COUNCIL ASSESSMENT REPORT

Panel Reference	PPSWES -171
DA Number	2023/38
LGA	Bathurst Regional
Proposed Development	Partial demolition, additions and alterations to an existing educational establishment (St Stanislaus College)
Street Address	220 Bentinck Street, Bathurst
Applicant/Owner	Henry Burnett of DFP Planning Pty Ltd on behalf of St Stanislaus' College Site owned by The Trustees of the Vincentian Fathers
Date of DA lodgement	16 February 2023
Total number of Submissions Number of Unique Objections	Zero
Recommendation	Approval
Regionally significant Development (Schedule 6 of the SEPP (Planning Systems) 2021	Capital investment value (CIV) of the development is \$28,534,000.00. This exceeds the CIV threshold of \$5 million for private infrastructure or community facilities for Council to determine the DA pursuant to Schedule 6 of State Environmental Planning Policy (Planning Systems) 2021.
List of all relevant s4.15(1)(a) matters	<ul style="list-style-type: none"> • Bathurst Regional Local Environmental Plan 2014 • State Environmental Planning Policy (Planning Systems) 2021. • State Environmental Planning Policy (Biodiversity and Conservation) 2021 • State Environmental Plannin

Figure 10 Site plan (source: David Group)

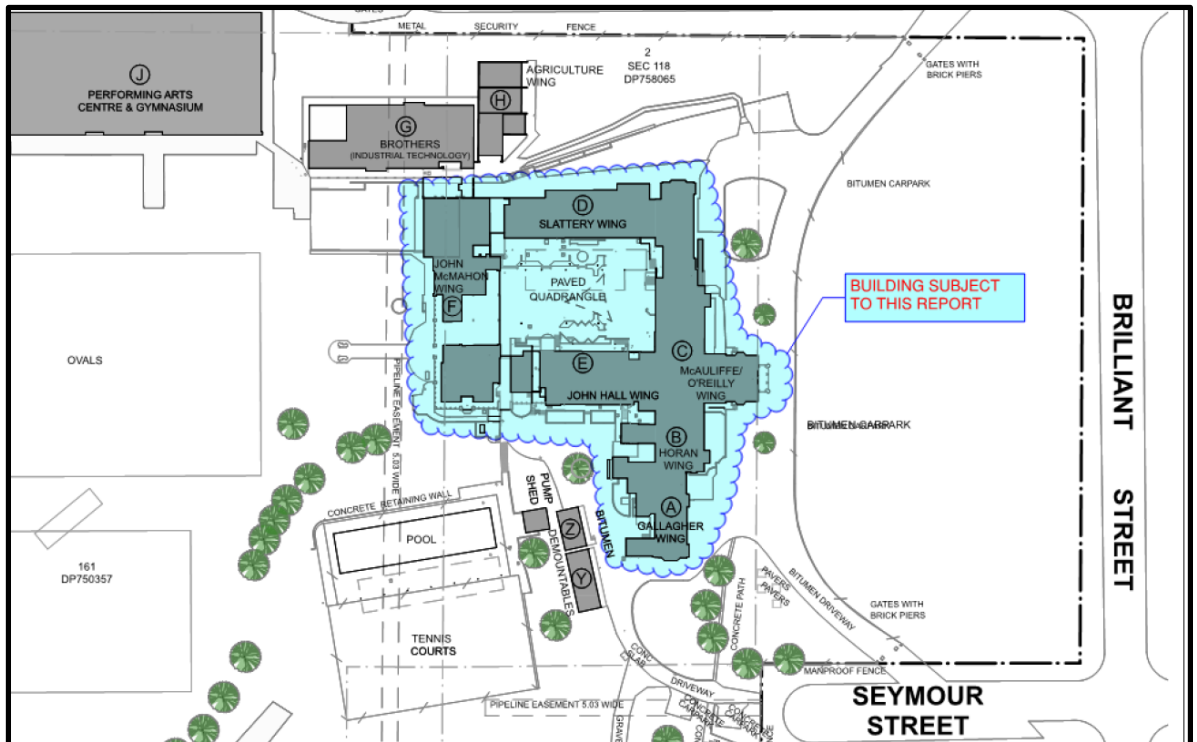
Having regard to Clause 64 of the Regulations it is considered that the building requires upgrading as it relates to fire, egress and spread of fire. The report from Davis Group dated 11/8/2023 has identified a large number of NCC non-compliances and in the opinion of Council, the existing building does not have adequate protection for occupants to exit the building in the event of an emergency. As such, because of the proposed redevelopment, the building should be upgraded in terms of fire safety and egress.

NOTE: When referring to 'the building' this is taken to mean the main school buildings as shown on page 8 of the Davis Group report. This building is divided into segments nominated as A, B, C, D, E and F.
